SERVICE BULLETIN No.1159

COACH MODEL : C2045

MANUAL SECTION : Chapter 10 - HVAC System

: A/C compressor discharge line installation **SUBJECT**

Figure 1: Discharge line repair kit VH 10909541

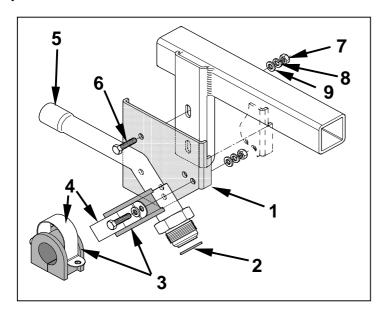
- 3. The kit comprises a replacement copper tube and fitting assembly, to be soldered to the existing coach tubing, a mounting rubber and clamp, a bracket and mounting hardware (see Figure 1, and parts information on page 2/12).

Figure 8: Field fix

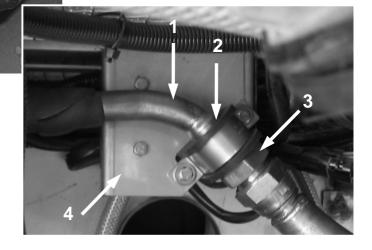
- 1. 45° bent tubing
- 2. Rubber mounting
- 3. Extended (long body) fitting
- 4. Additional bracket

NOTE: Do not consider this part of the procedure if your coach has already been fitted with the copper discharge line means of support shown in Figures 7 or 8. As a next step, proceed with the installation of the new rubber flex hose (steps 1 and 17 only).

Figure 10: LH discharge line support bracket next to engine

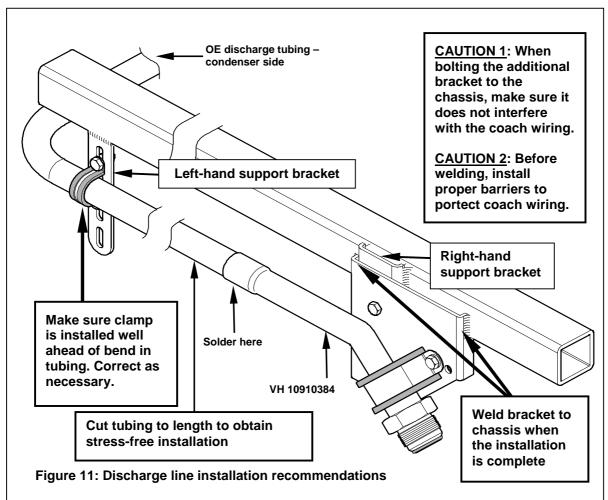
3) At the LH discharge line support bracket (see Figure 10), undo and remove the bolts, nuts, washers and hose clamp securing the tubing to the chassis. Recover the clamp and fasteners.
